# NORTH WEST **cambridge**

Section 73  
Design Statement  
September 2013

This Design Statement accompanies a Section 73 application made by the North West Cambridge Project Team on behalf of the University of Cambridge in relation to the outline consent for North West Cambridge scheme (11/1114/OUT and S/1886/11).

- Condition 69: Drawing Numbers –revised Parameter Plans will be submitted as part of the Section 73 Application, to address amendments to the heights in the local centre and revised positioning of the Community Centre through detailed design.

West Elevation: the two locations where the parameter plan was exceeded is shown above, to the North West Block and the Energy Centre chimney. Both locations exceeded the permitted height by approximately 1.35m.

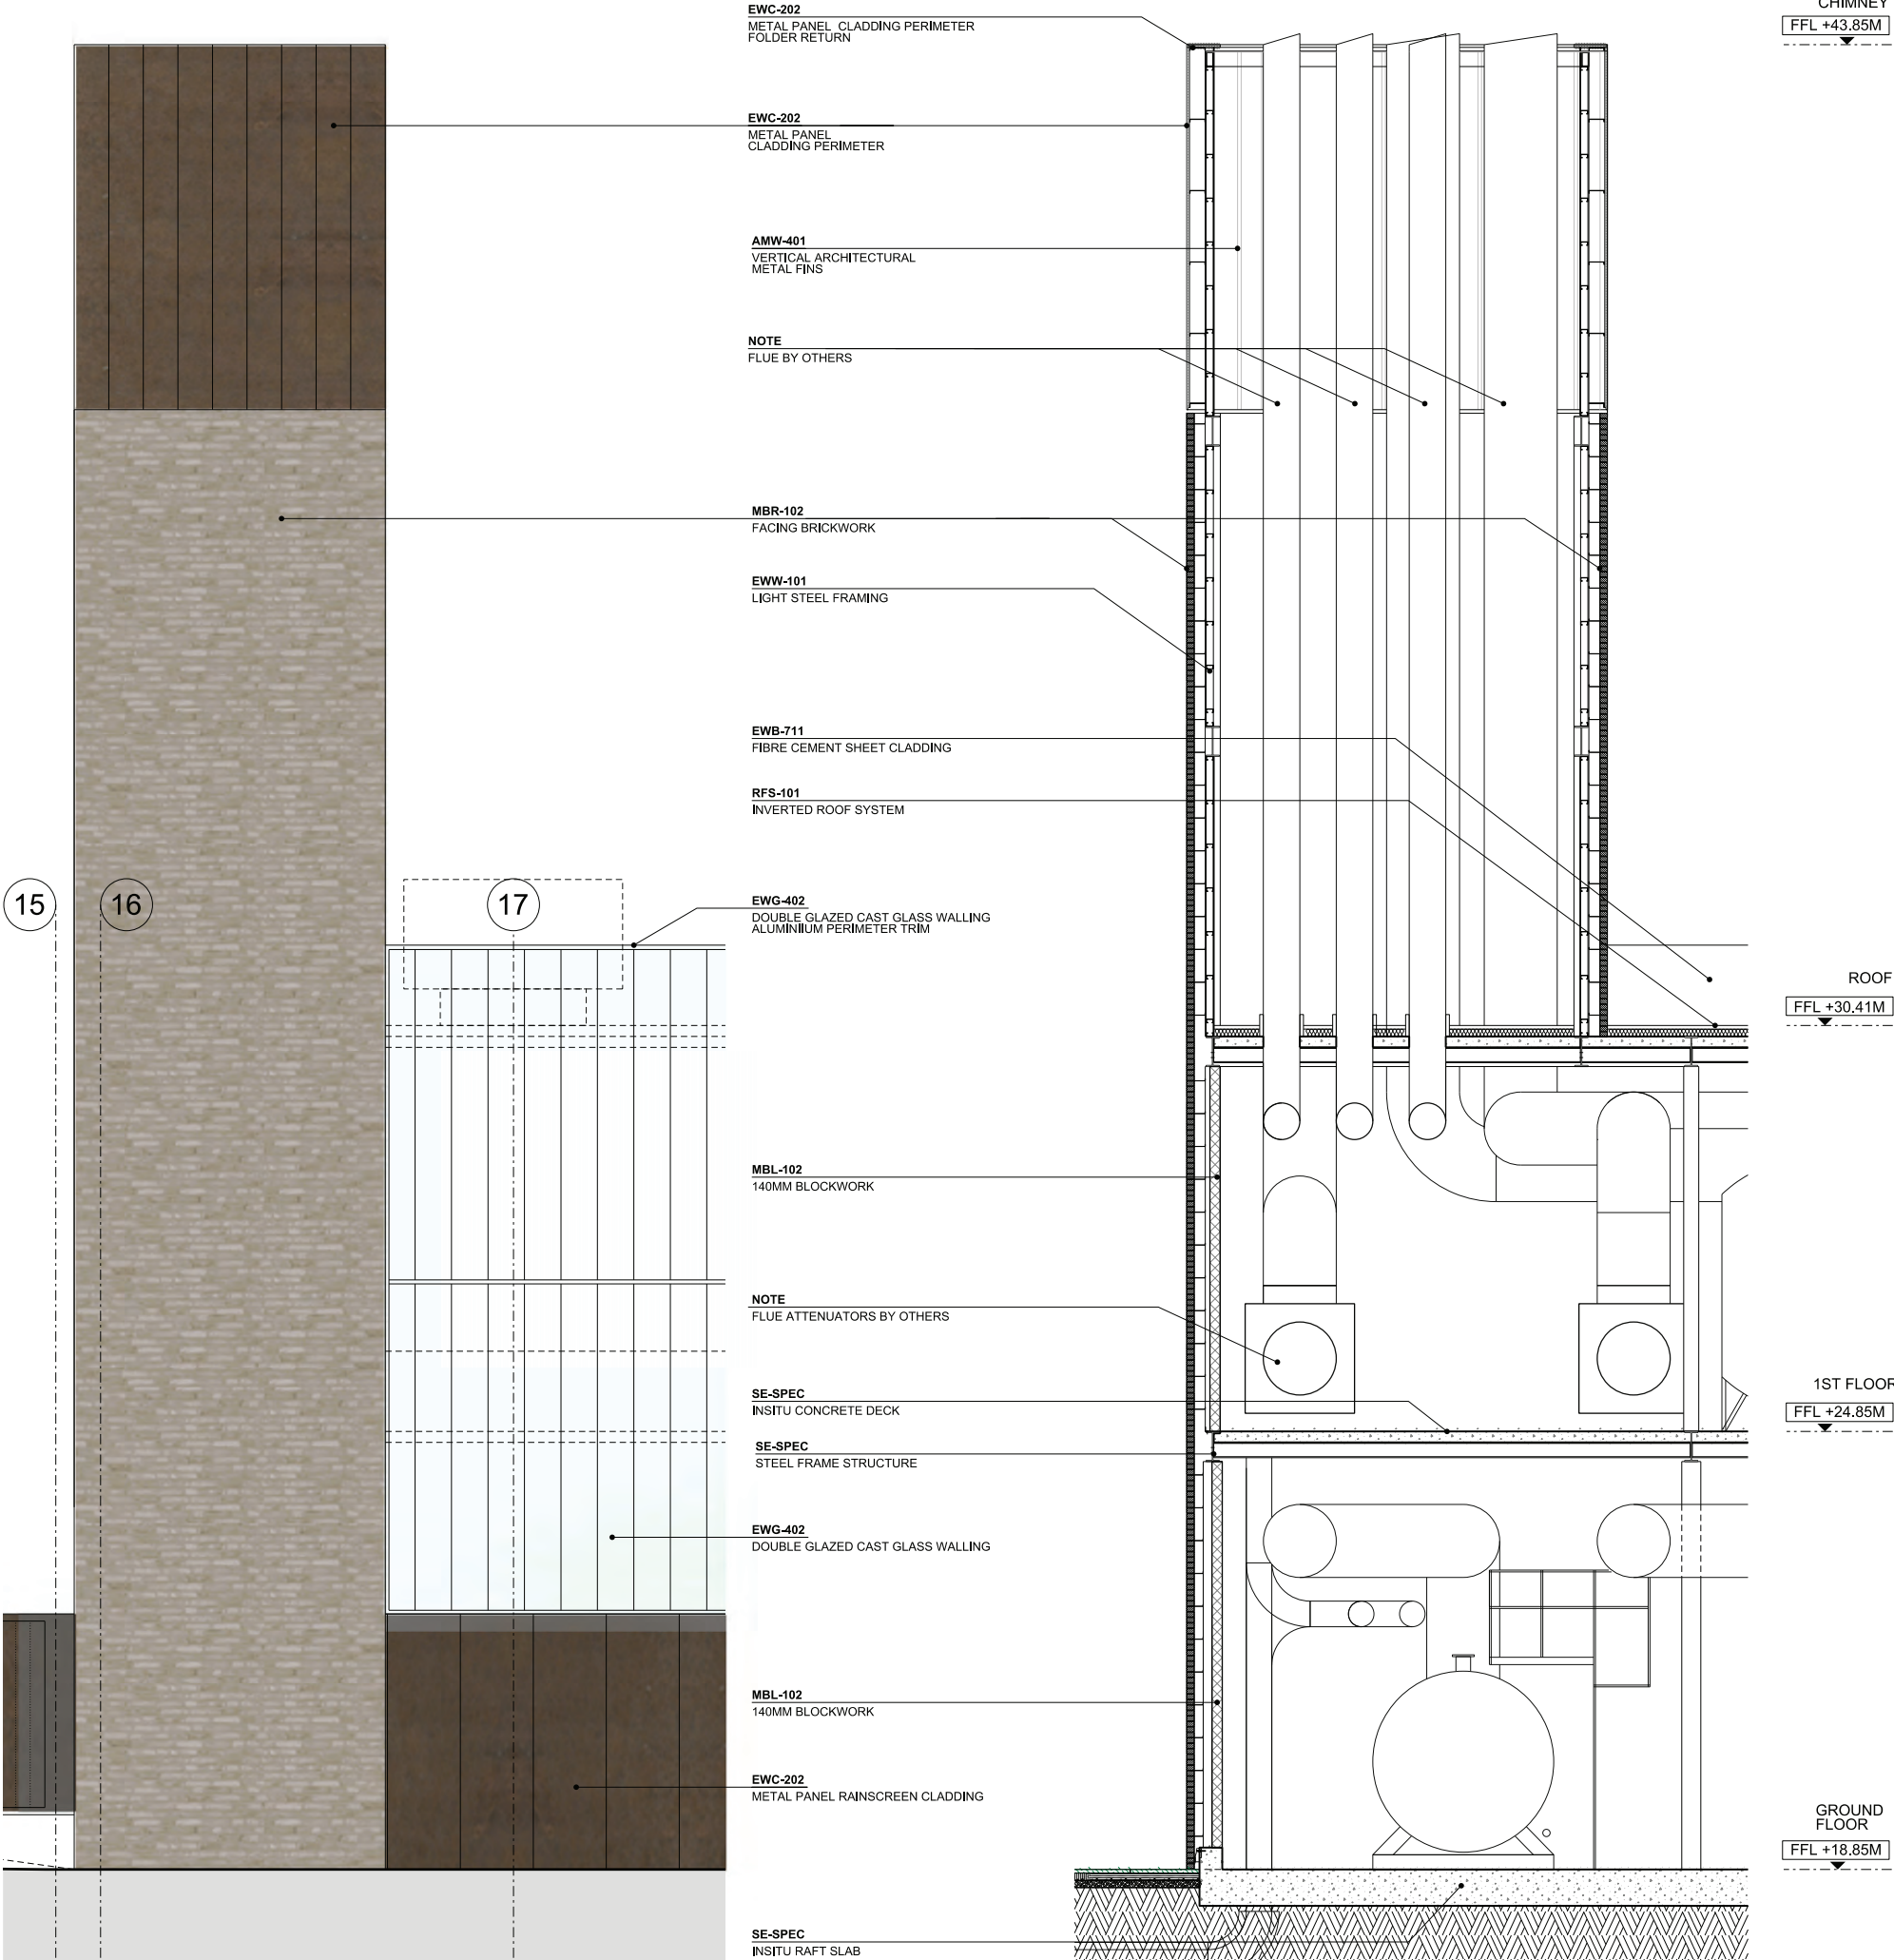
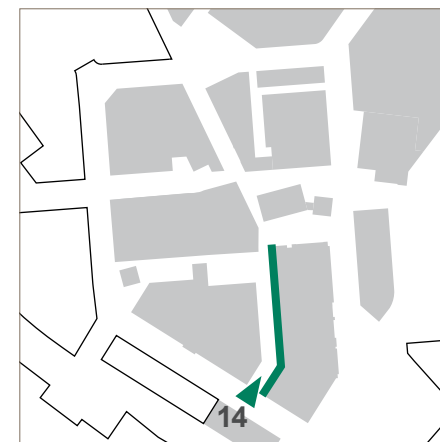
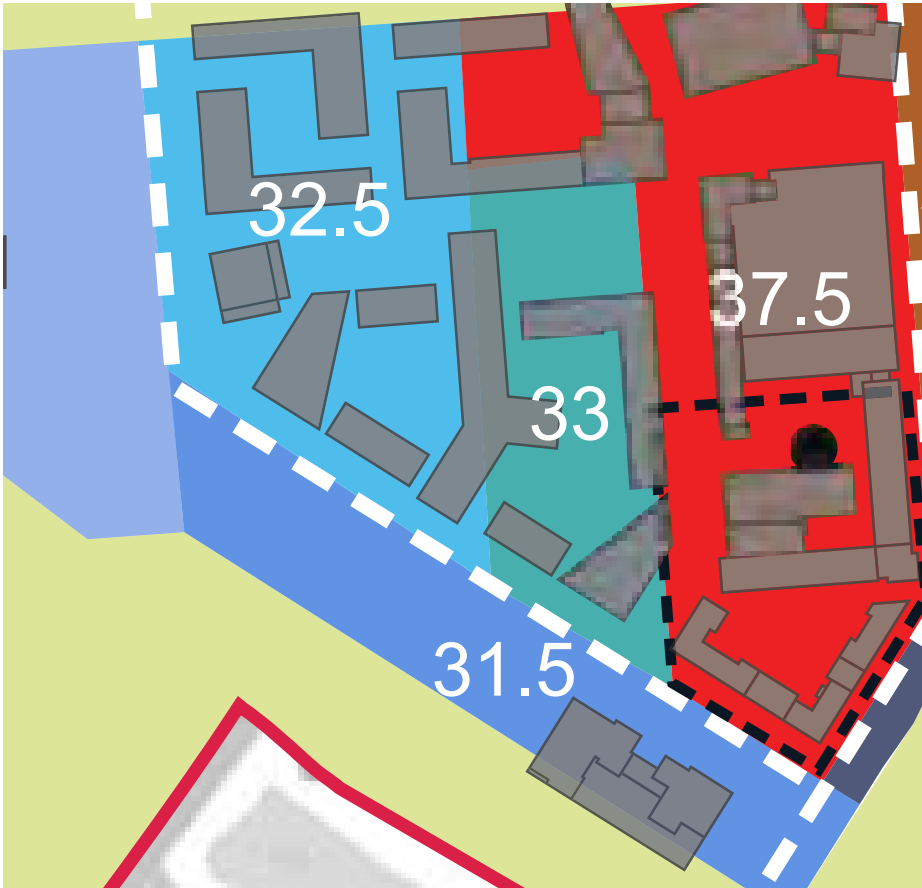
The buildings proposed within this Lot comply with Parameter Plan 05 with the maximum building height less than 18m above ground level. However, in two locations the buildings do not comply with Parameter Plan 06 with the maximum breach being 1.35m over the AOD in both these locations. These areas are demonstrated on the plans below:

The flue, which forms part of the Energy Centre, is the second area in Lot 1 where the height parameter plan is breached. This exceedance is driven by the detailed technical and design work which has been undertaken following the granting of permission into what is exactly required for an Energy Centre serving this size of development. It was found that not only would this flue be required to be slightly higher than the previously approved height parameter of 42.5m AOD, it would also have to be considerably wider and a square rather than a circular shaped chimney. Various studies were undertaken to ascertain whether a slimmer design could be implemented.

Reduction in flue diameters would increase exhaust gas velocities resulting in additional fan energy (unable to achieve without fans) and noise.

Lot 3 - East elevation on Tertiary Street facing Lot 1, the eastern corner block exceeded Parameter Plan 06 AOD by 1.4m.

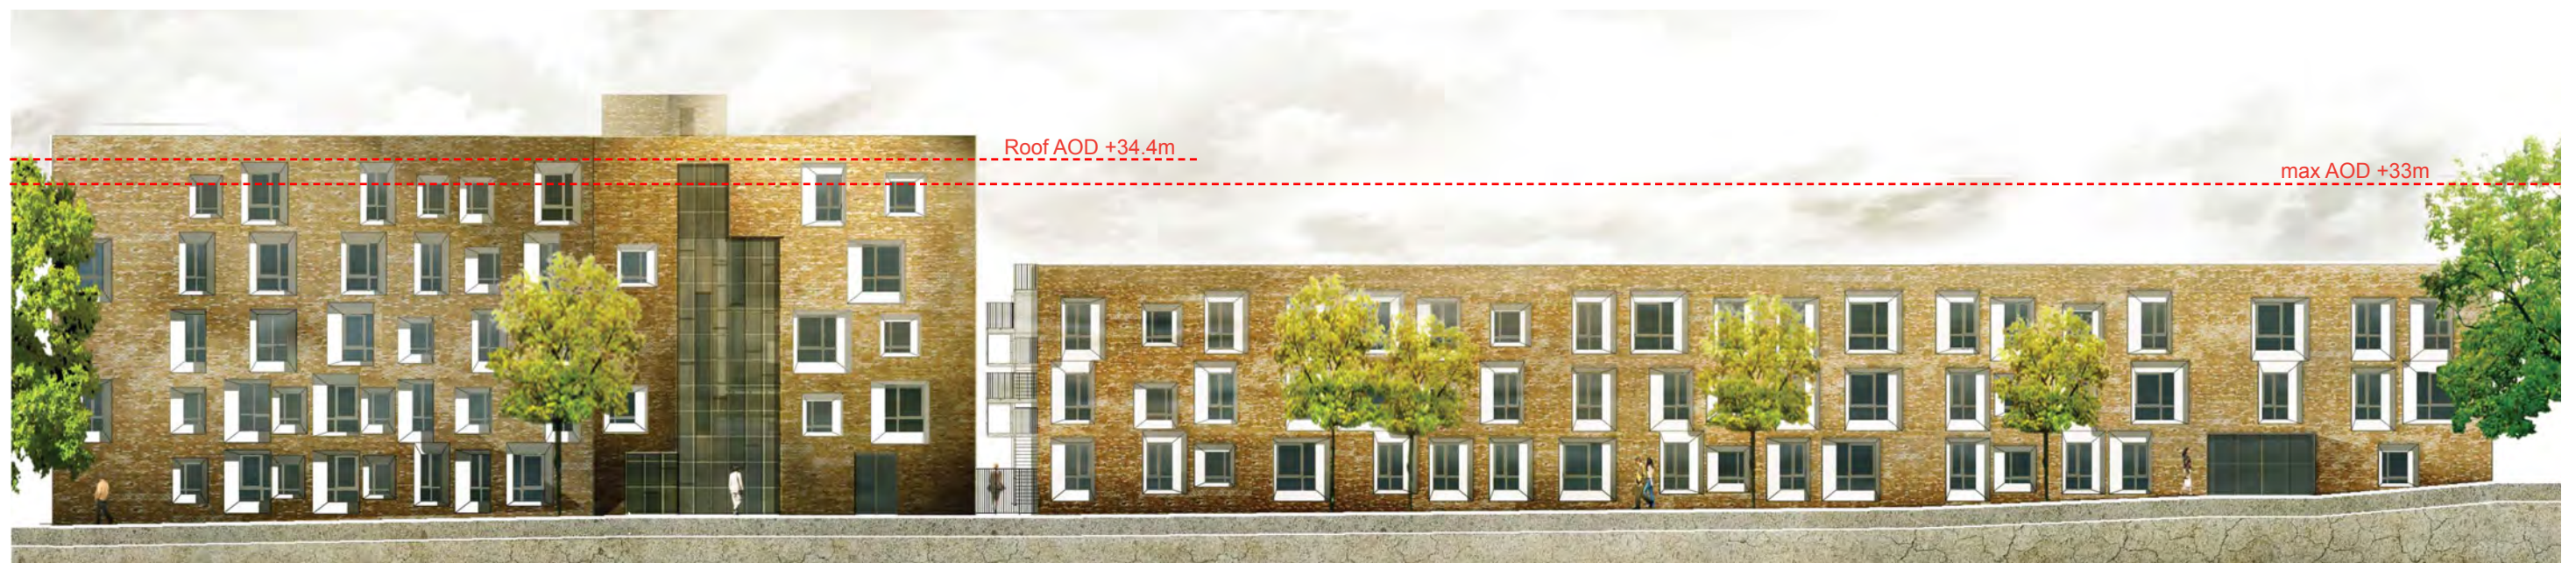
The buildings within this Lot currently comply with Parameter Plan 05 with the maximum building height less than 15m above ground level. However, these buildings do not comply with Parameter Plan 06. There are two AOD levels on Lot 3 (33m to the east and 32.5m to the west), and only part of the central Spine Building, which is currently proposed at 5 storeys, breaches the western zone by 1.9m. The eastern corner block breaches the eastern zone by 1.4m.

Lot 7 - Current layout overlay on February 2013 Building Heights Parameter Plan

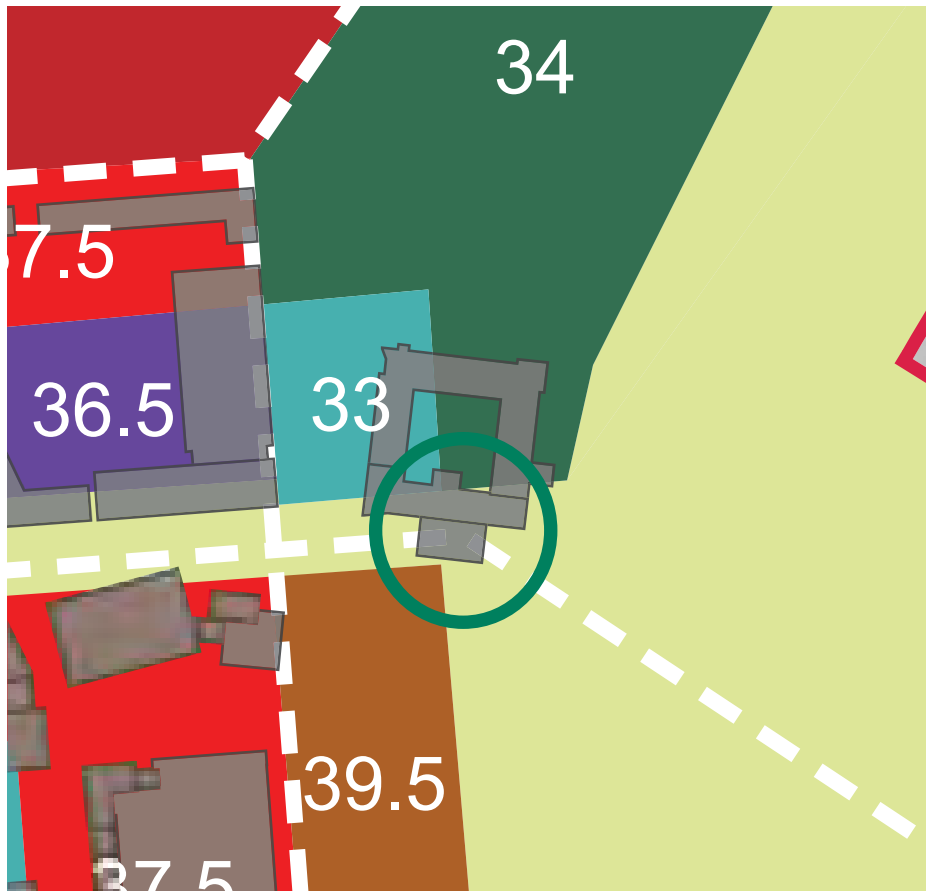
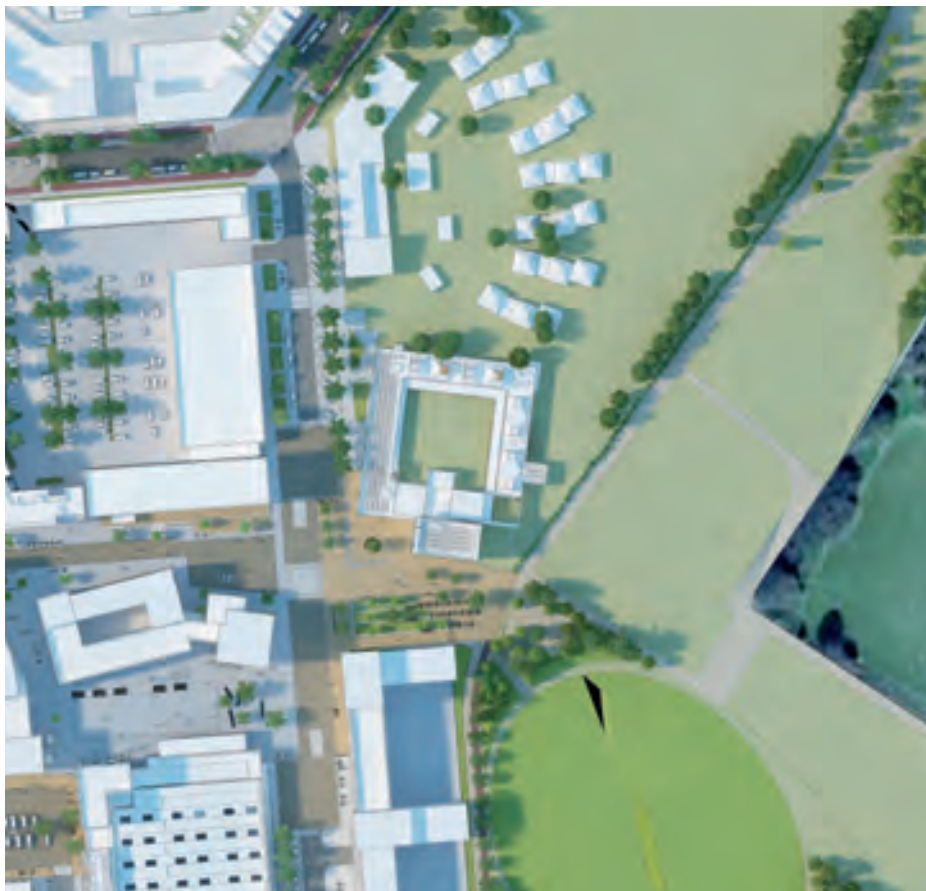
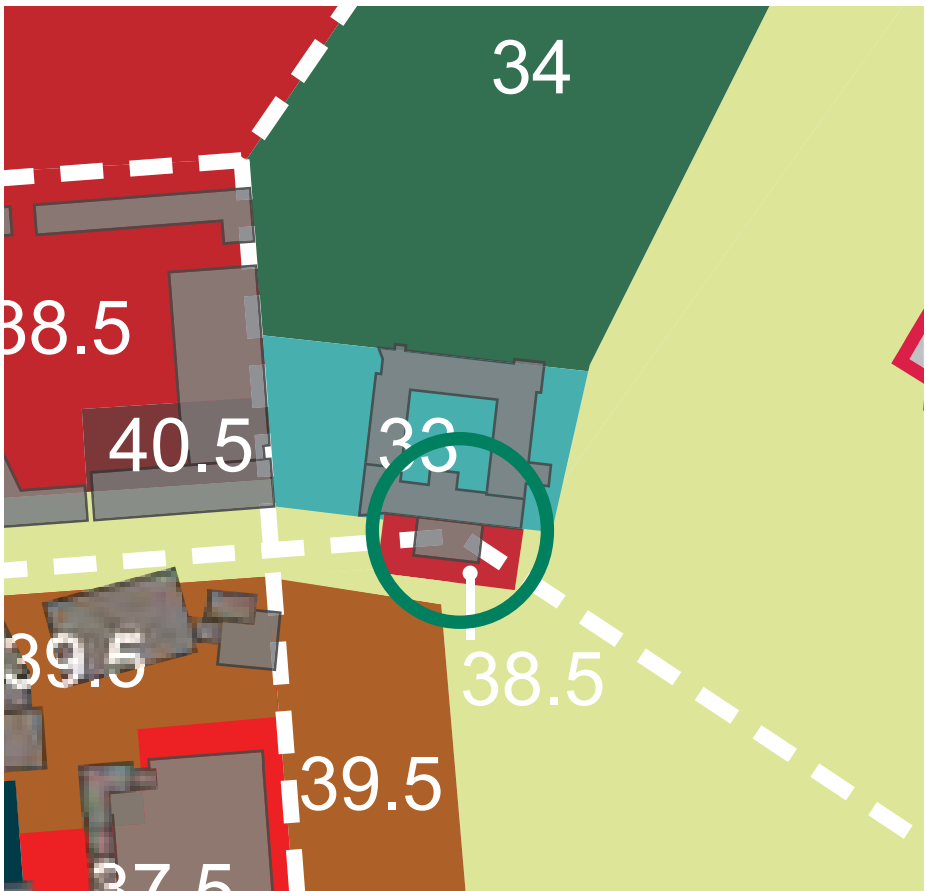
In relation to heights, the majority of Lot 7 complies with the approved height parameter plans. However, the Main Hall within the Community Centre does not comply with Parameter Plan 05 most of which falls within three zones O(8m), L(10m) and K(18m). Parts of the building which are within Zone K are compliant. Furthermore the Main Hall does not comply with Parameter Plan 06 as shown in the section on the next page, with a maximum breach of 5m over the AOD. These breaches in height are a direct result of the design of the building which has been developed to maximise the number and type of activities which could take place within the Community Centre.

Lot 7 - Current layout overlay on Proposed changes of Building Heights Parameter Plan

Lot 7 - Current layout overlay on February 2013 Open Land and Landscape Areas Parameter Plan

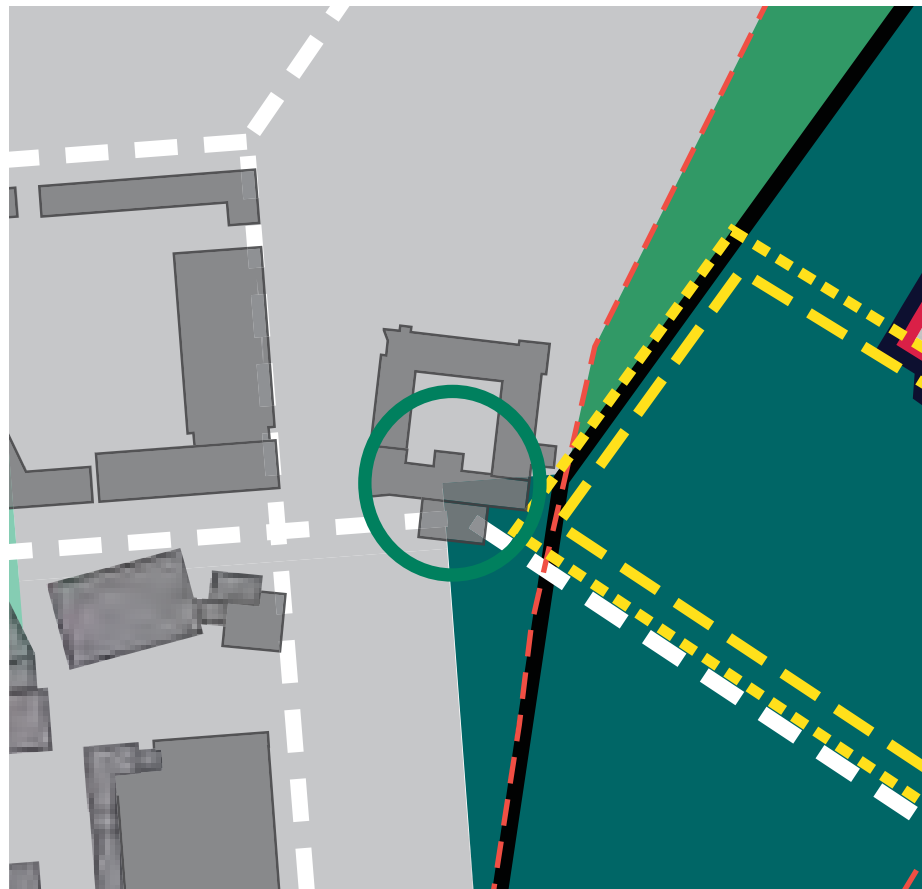
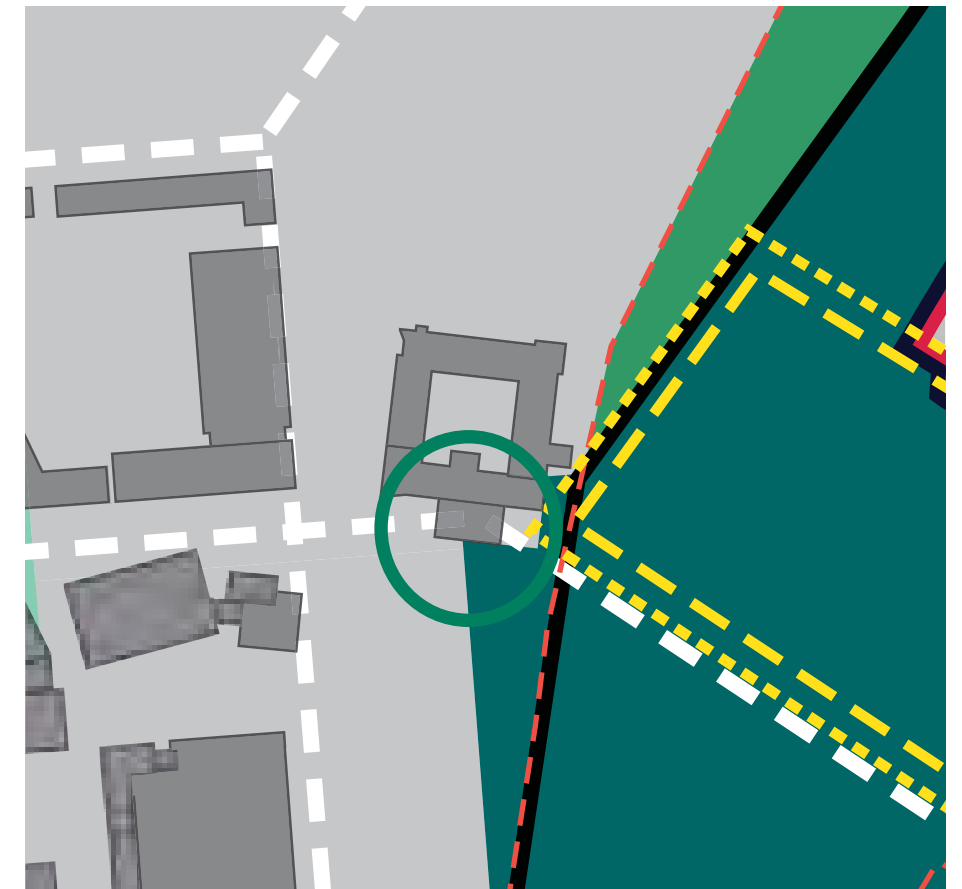
The second amendment to parameter plans relates to the re-alignment of the Community Centre. Given its role in the community, Lot 7 is presented as a key focal point in the Local Centre around the Market Square and for those entering the site along the Ridgeway from the West arriving from Storey's Field. The Community Centre is identified as a landmark building within the approved Design Code and therefore it was felt that by pivoting the building this landmark would be emphasised. (See layout overlay on the diagrams below). Therefore, as a result its location now extends into a small area of Primary Open Land. This Section 73 Application seeks to amend those parameter plans to which this relates.

Lot 7 - Current layout overlay on Proposed changes of Open Land and Landscape Areas Parameter Plan
